## Block 8, Central Park – Response to Submissions

### City of Sydney (CoS)

#### Internal Amenity

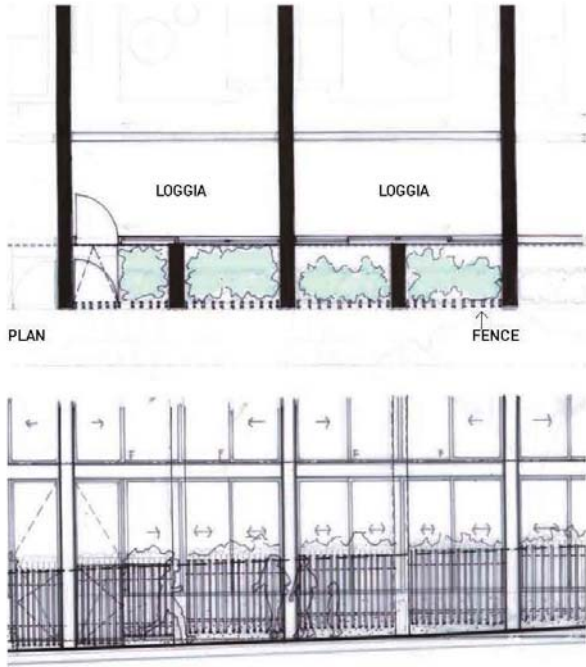
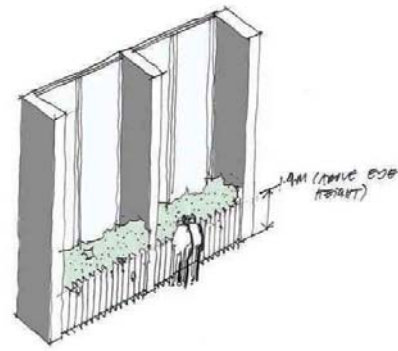
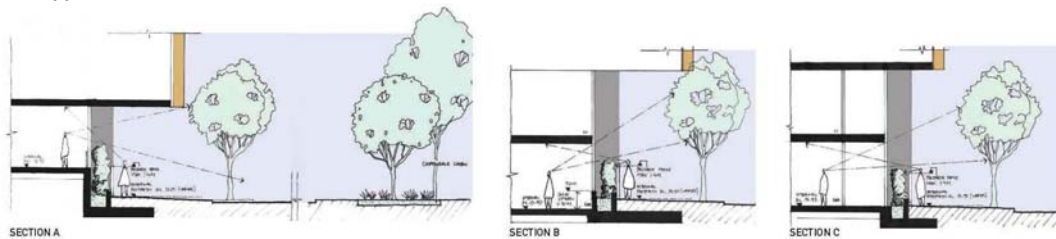
- The proposal includes single aspect studio apartments that range between 10.8m and 13.4m in depth. The proposed units are considered excessive in depth and do not comply with the maximum 8 metre depth for single aspect studio apartments as recommended in the Residential Flat Design Code (RFDC).
- The City acknowledges that borrowing amenity for the bedroom area of a studio from an adjoining living area is capable of satisfying minimum standards for natural light and ventilation under the Building Code of Australia. However, the City does not consider the reliance on borrowed amenity as best practice or quality design for internal residential amenity.
- The City believes that internal configuration of apartments and residential amenity can be enhanced if the depths of single aspect apartments are reduced to comply with the

See Sections 2.1.1 – 2.1.3 of Response to Submissions Report.
